TRANSMITTAL OF THE FINAL SAMPLING AND ANALYSIS PLAN, CHARACTERIZATION OF THE 903 PAD/RYAN'S PIT AND EAST TRENCHES PLUMES - JEL-052-98

**SAMPLING AND ANALYSIS PLAN
CHARACTERIZATION OF THE
903 PAD/RYAN'S PIT AND
EAST TRENCHES PLUMES**

**ADDENDUM TO
SAMPLING AND ANALYSIS PLAN
CHARACTERIZATION OF THE
903 PAD/RYAN'S PIT AND
EAST TRENCHES PLUMES**

**Colorado Department of Public Health and Environment
Hazardous Material and Waste Management Division
comments on**

PREPARED FOR:			
ROCKY FLATS ENVIRONMENTAL TECHNOLOGY SITE Golden, Colorado			
FIGURE 2			
TITLE:			
903 PAD/RYAN'S PIT PLUME STUDY AREA			
PROJ. NO.	774115	DWG. NO.	4115B003
DESIGN BY	ZT	CHECKED	xx
DRAWN BY	JDL	APPROVED	xx
DATE	1-21-98	SCALE	1:100
			SHEET 2 OF 3

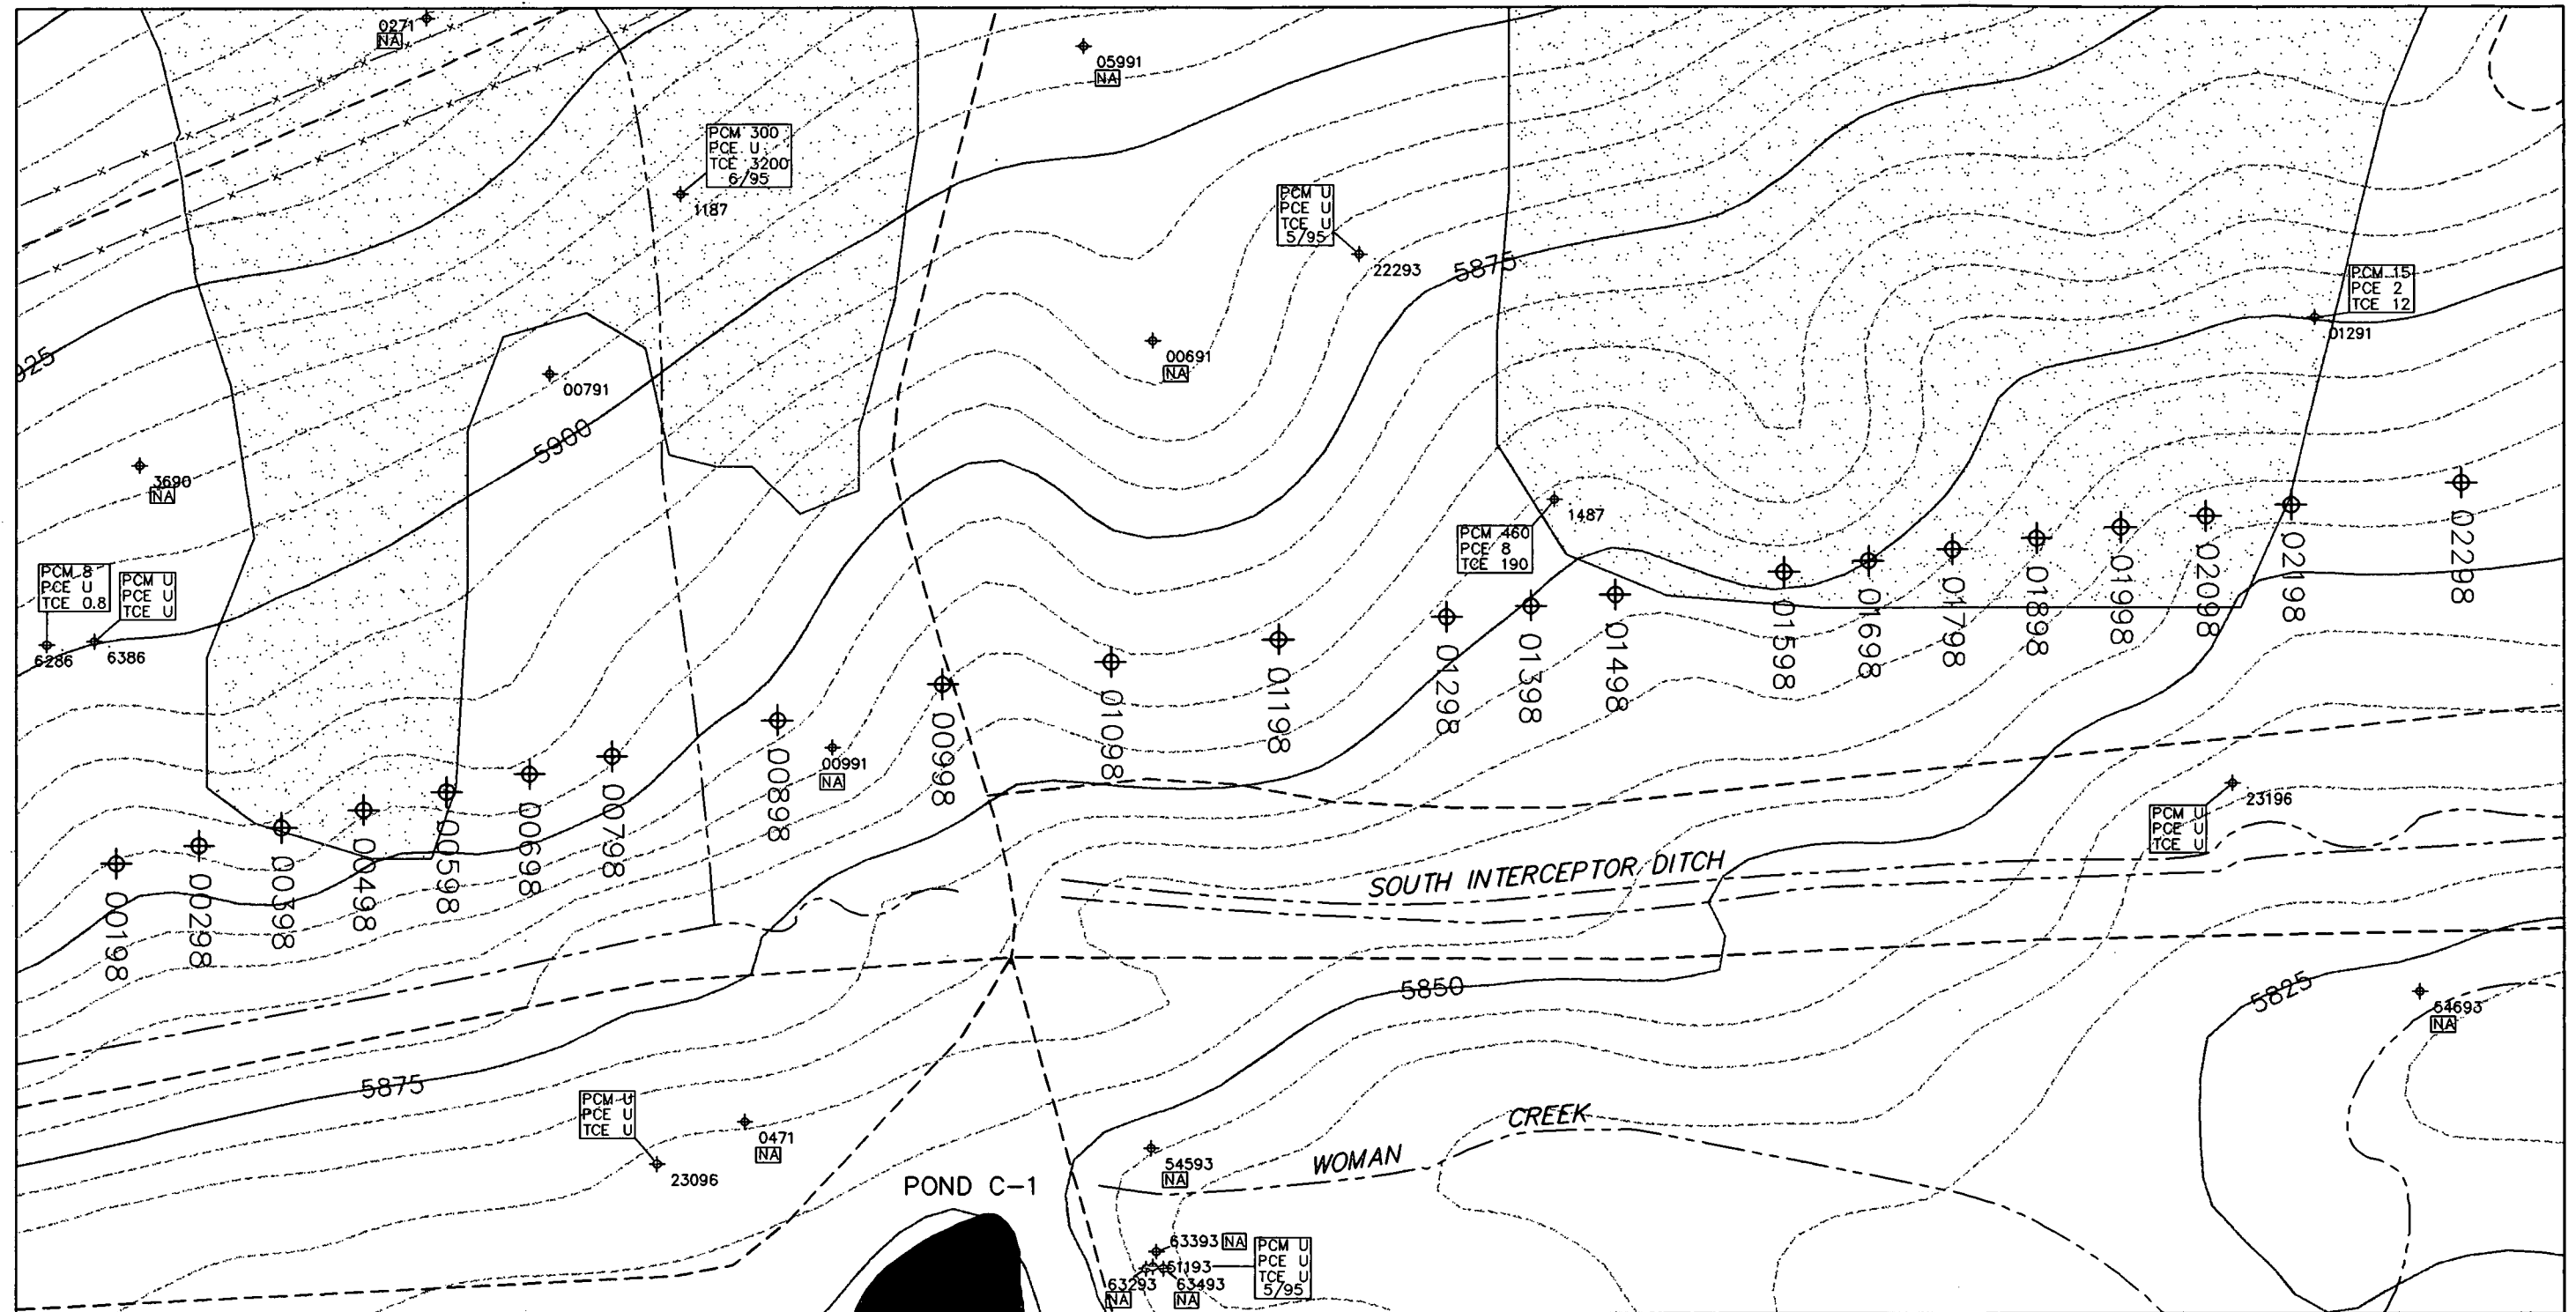
2. All the wells represented within the boundaries of Figures 2 and 3 are labeled with the groundwater concentration data. If analysis was not available, the well was either labeled with "NA" for no data available, or "DRY" if no water was present. The wells originally in question, 02697, 02797 and 02897 have been labeled.

**EAST TRENCHES
PLUME STUDY AREA**

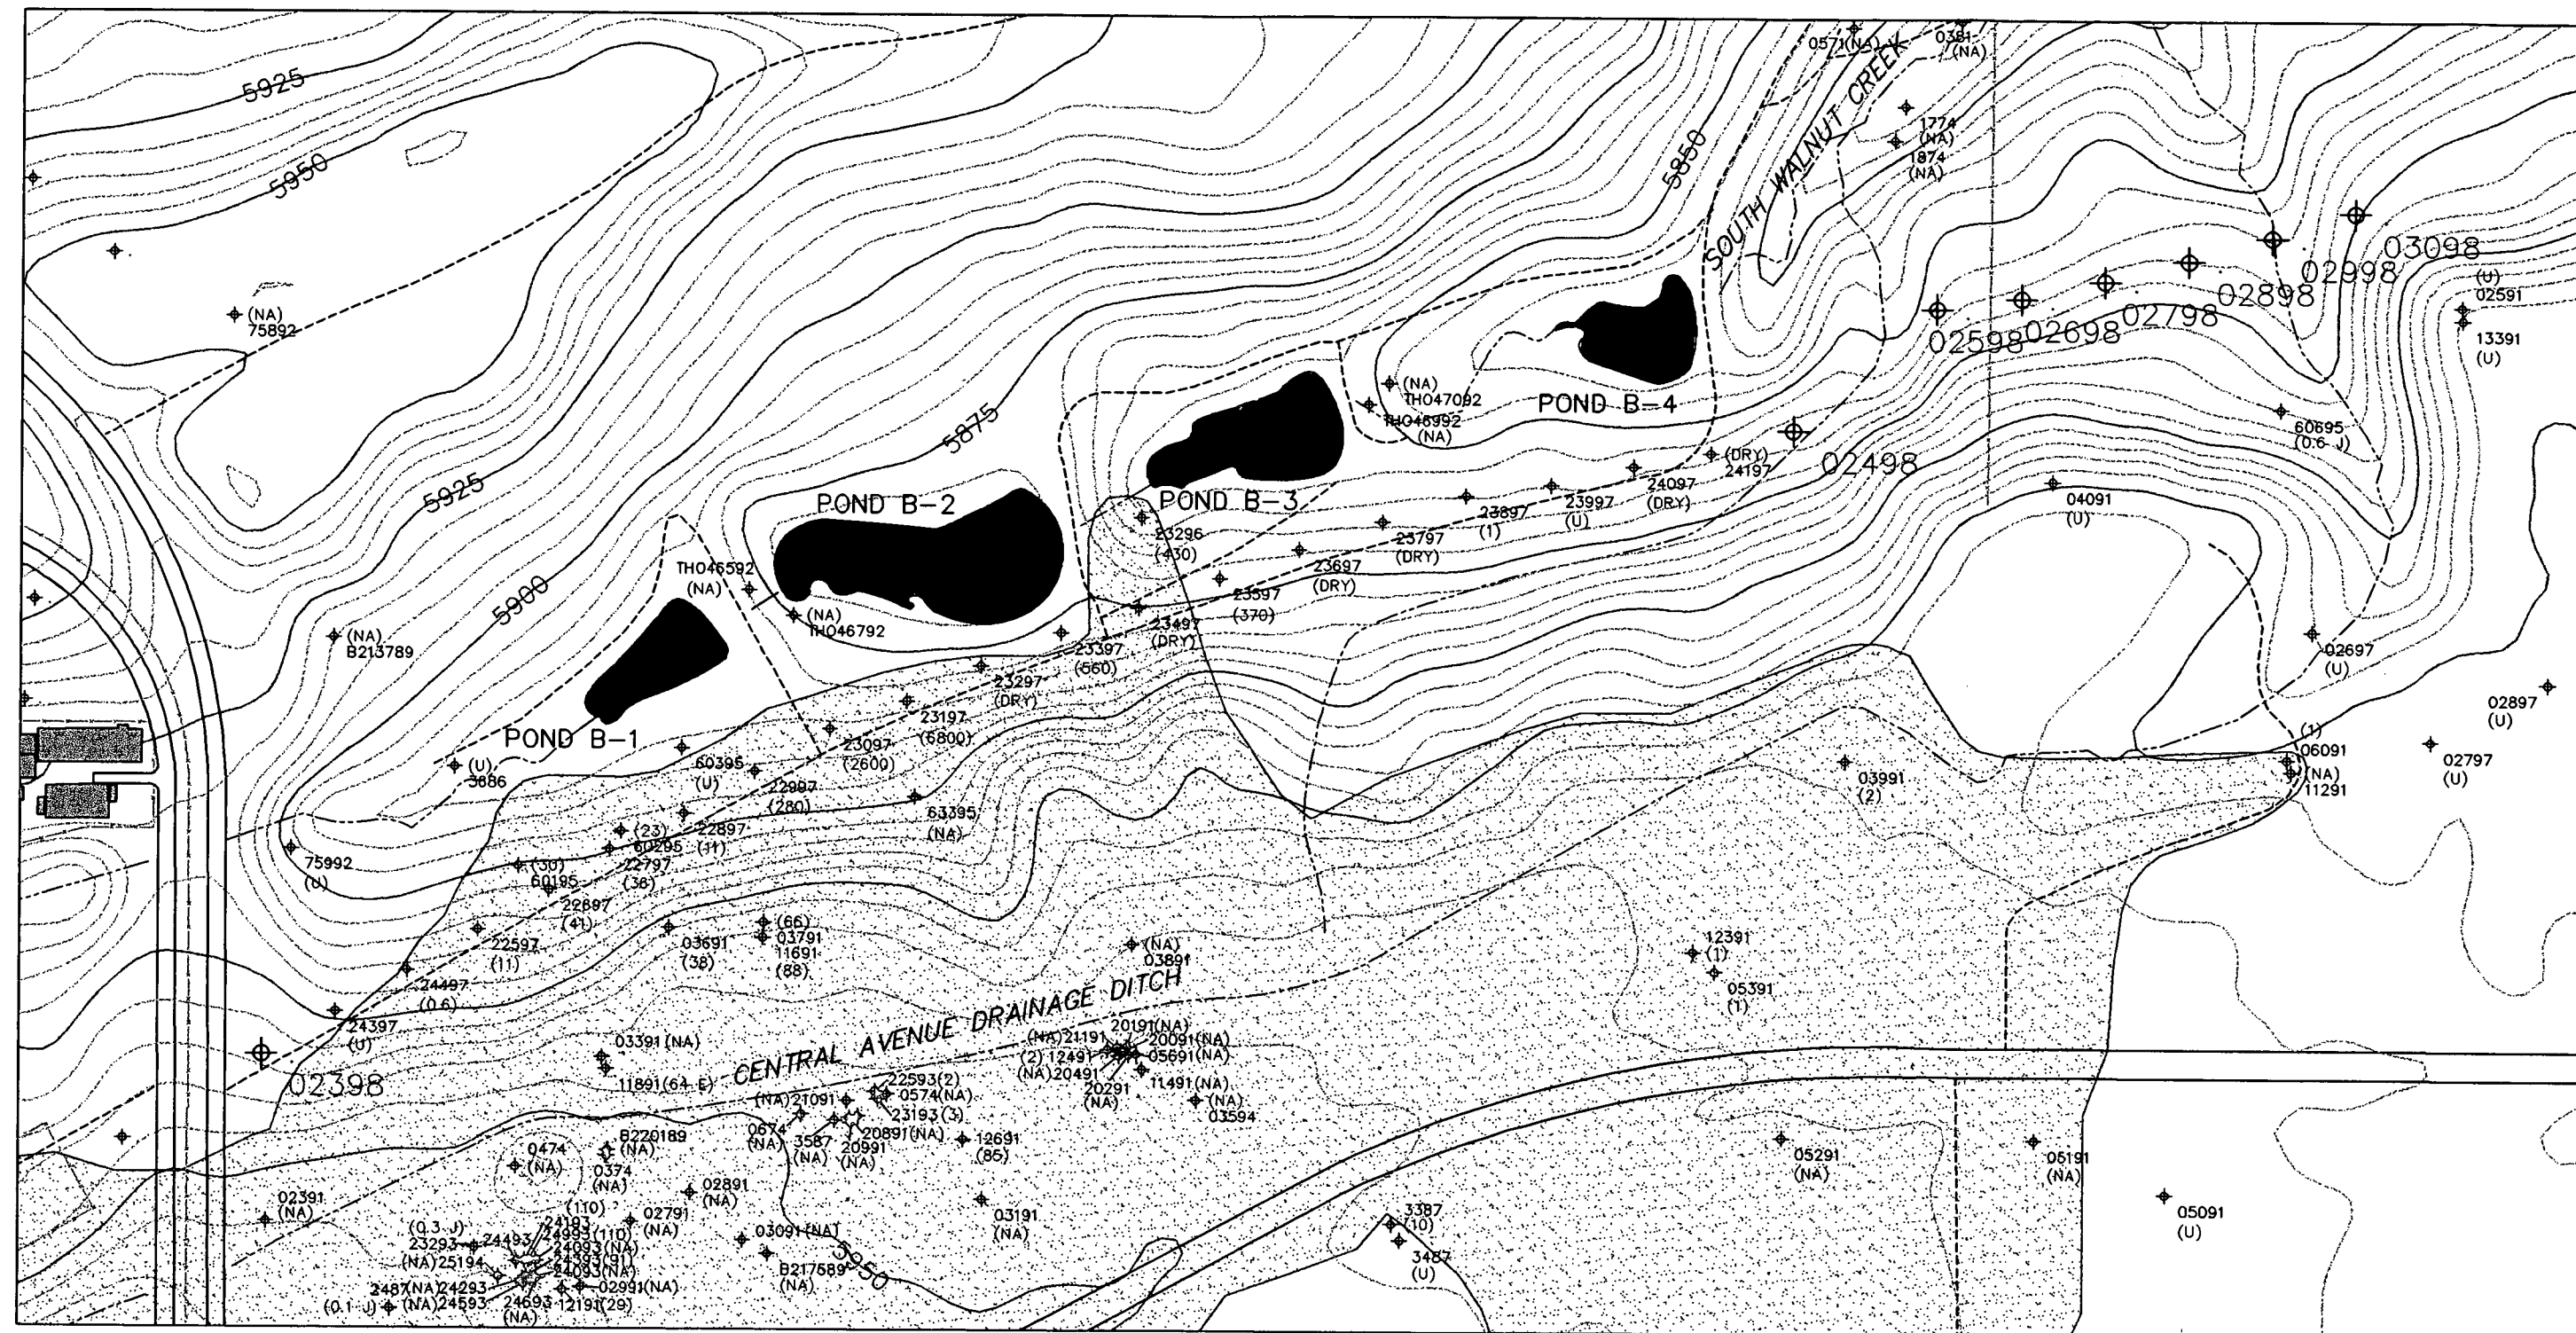
11. Figure 3 has been changed, the Tier I plume configuration located in the south central part of the figure, east of wells 20091 and 05691 was removed, as current data does not support Tier I concentrations in this area.

Figure 3 presents recent concentrations of trichloroethene in groundwater for a portion of the East Trenches Plume. Also shown is the extent of the VOC plume as defined by an exceedance of the Tier II action level for one or more plume constituents, as presented in the 1996 Annual RFCA Groundwater Monitoring Report (RMRS, 1997b). The plume extent shown does not incorporate 1997 data from the recently installed geoprobe wells. The boundary of the plume exceeding Tier II action levels is not shown. The characterization letter report (item 7) will include revised plume boundaries.
